Contract #: 04-0120F4
 Cty: SF/ALA Rte: 80 PM: 13.2/13.9
 File #: 69.25B

QUALITY ASSURANCE -- NON-CONFORMANCE REPORT

Subject: NCR No. ZPMC-0297

Reference Description: Gouge Weld Metal / South Shaft Lift 1 / 38m Diaphragm to Skin E Weld

Reference Description: Tower, Lift 1, 38m diaphragm to skin E weld gouge

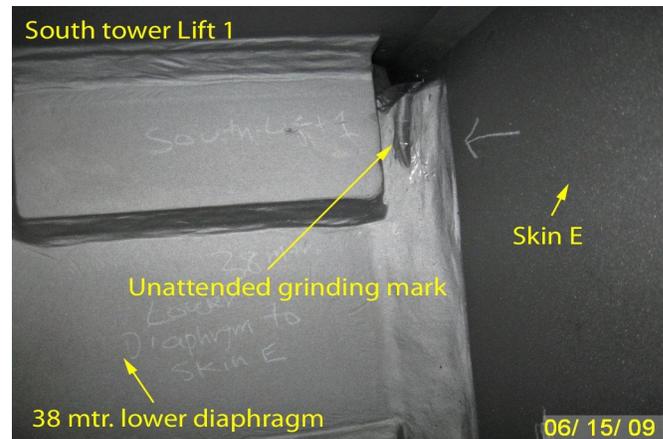
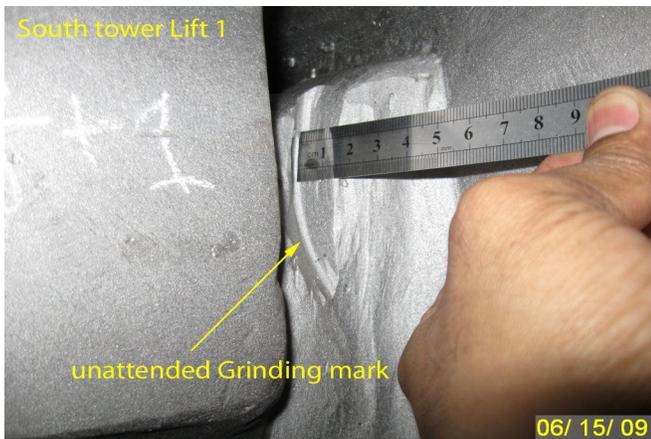
QA observed a 12mm deep gouge in 38m diaphragm to skin E weld during after grit blast random verification of South Tower, Lift 1. This weld was previously accepted by ZPMC QC personnel.

AWS D 1.5-2002, Section 3.7.1 - "The removal of weld metal or portions of the base metal may be done by machining, air carbon arc cutting and gouging, thermal cutting, chipping, or grinding. It shall be done in such a manner that the remaining weld metal or base metal is not nicked or undercut..."

Reference Description: Tower, Lift 1, 38m diaphragm to skin E weld gouge

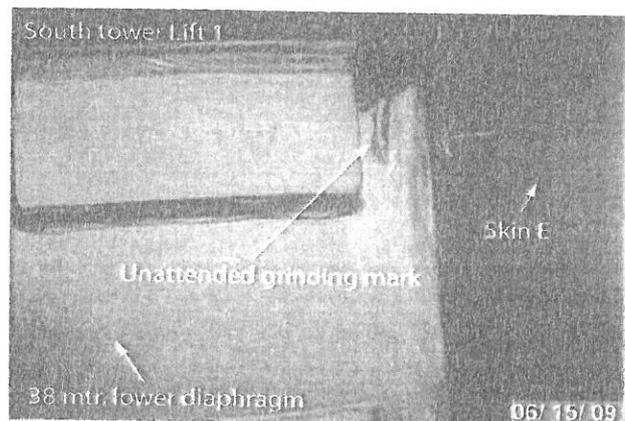
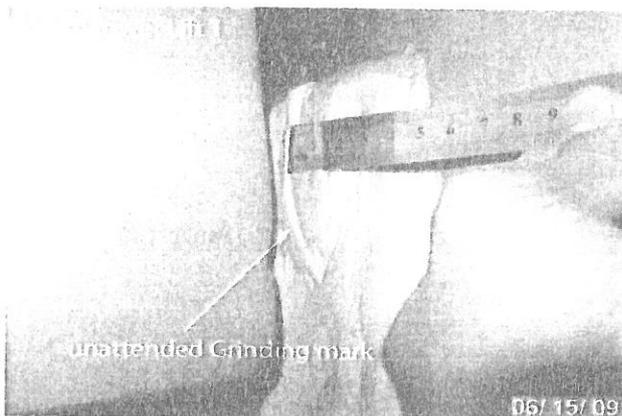
QA observed a 12mm deep gouge in 38m diaphragm to skin E weld during after grit blast random verification of South Tower, Lift 1. This weld was previously accepted by ZPMC QC personnel.

AWS D 1.5-2002, Section 3.7.1 - "The removal of weld metal or portions of the base metal may be done by machining, air carbon arc cutting and gouging, thermal cutting, chipping, or grinding. It shall be done in such a manner that the remaining weld metal or base metal is not nicked or undercut..."

Reference Description: Tower, Lift 1, 38m diaphragm to skin E weld gouge

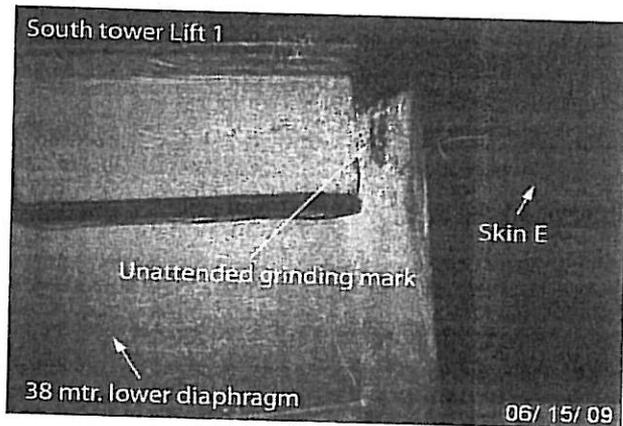
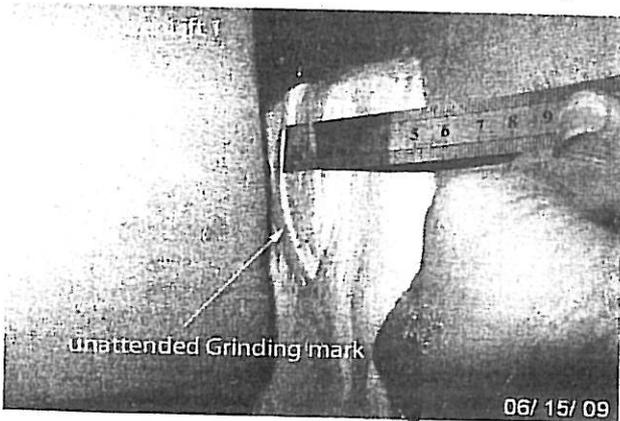
QA observed a 12mm deep gouge in 38m diaphragm to skin E weld during after grit blast random verification of South Tower, Lift 1. This weld was previously accepted by ZPMC QC personnel.

AWS D 1.5-2002, Section 3.7.1 - "The removal of weld metal or portions of the base metal may be done by machining, air carbon arc cutting and gouging, thermal cutting, chipping, or grinding. It shall be done in such a manner that the remaining weld metal or base metal is not nicked or undercut..."
